H. B. ROBINSON STEAM ELECTRIC PLANT, UNIT NO. 2

AMENDMENT TO FACILITY OPERATING LICENSE

Amendment No. 71
License No. DPR-23

AMENDMENT NO. 71 TO FACILITY OPERATING LICENSE NO. DPR-23

FIGURE 3.10-1

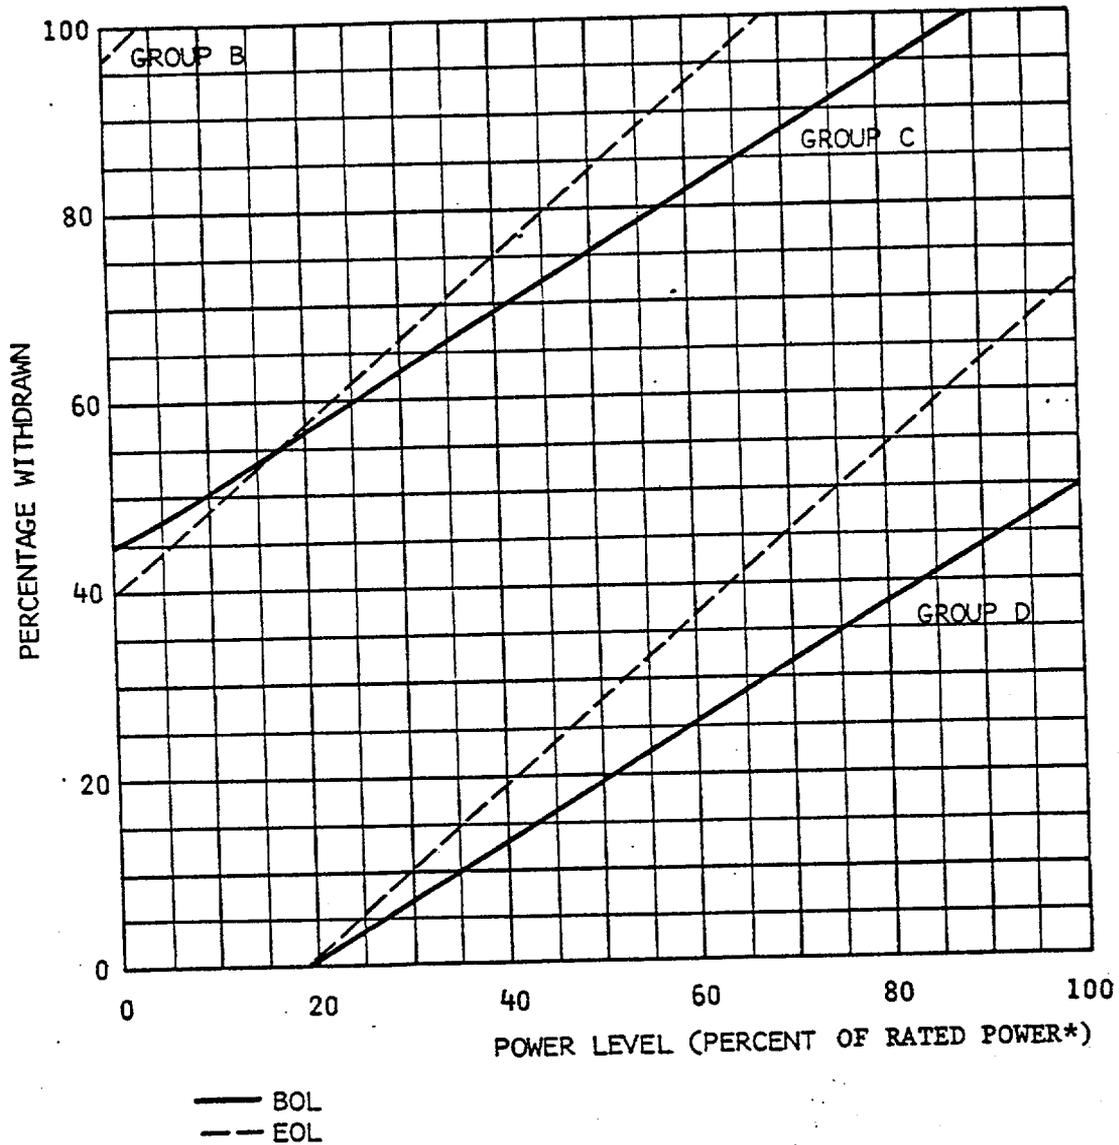
CONTROL GROUP INSERTION LIMITS FOR
THREE LOOP OPERATION
